Airworthiness Directives; Sikorsky Aircraft Corporation (Sikorsky) Model S-92A Helicopters

ACTION: Notice of proposed rulemaking (NPRM).

Sikorsky Aircraft Corporation: Docket No. FAA–2011–1115; Directorate Identifier 2010–SW–011–AD.

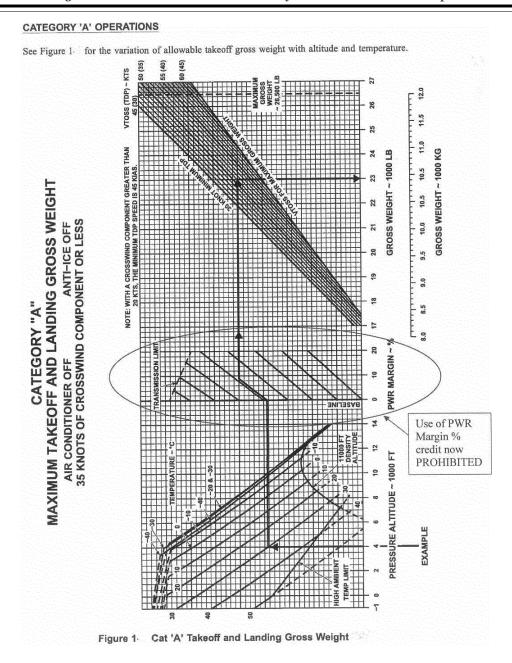
Note 1: Previous RFM revisions allowed for the use of above-specification engine power margin as depicted in the circled area of Figure 1 of this AD.

- (a) By making pen and ink changes, insert into the Operating Limitations section, Part 1, Section 1, Weight Limits, of RFM SA S92A–RFM–002, –003, –004, –005, and –006 the following limitation "Performance credit for above specification engine power margin is prohibited."
- (b) If the RFM already contains the revisions appropriate for your helicopter as listed in the following Table 1, all dated April 9, 2008, with the correct performance charts, without the performance credit as depicted in the circled area of Figure 1 of this AD, the operating limitation required by paragraph (a) of this AD does not need to be inserted into the RFM.
